Inspect your fuel pump impulse line!

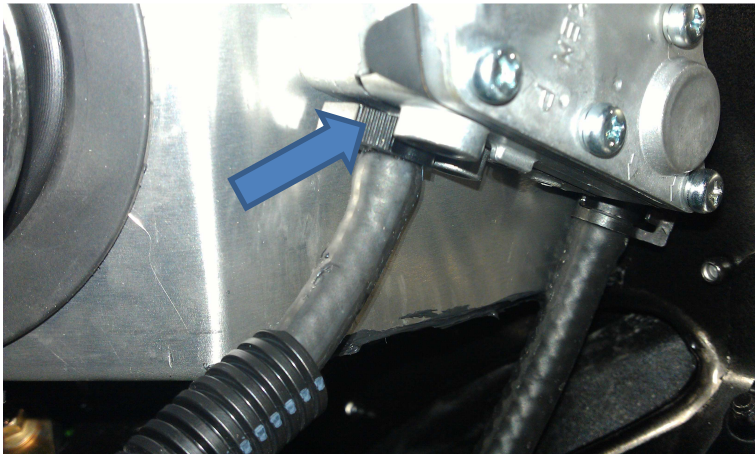
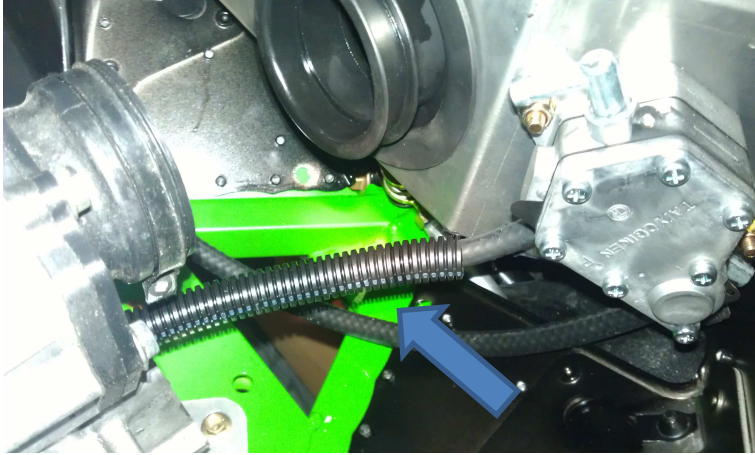
We have seen where the hose seems on the short side and develops a crack at the nipple coming off the fuel pump, this can create a bad hesitation and or bog most noticeable on hard landings.

We suggest replacing impulse line with a 2" longer line
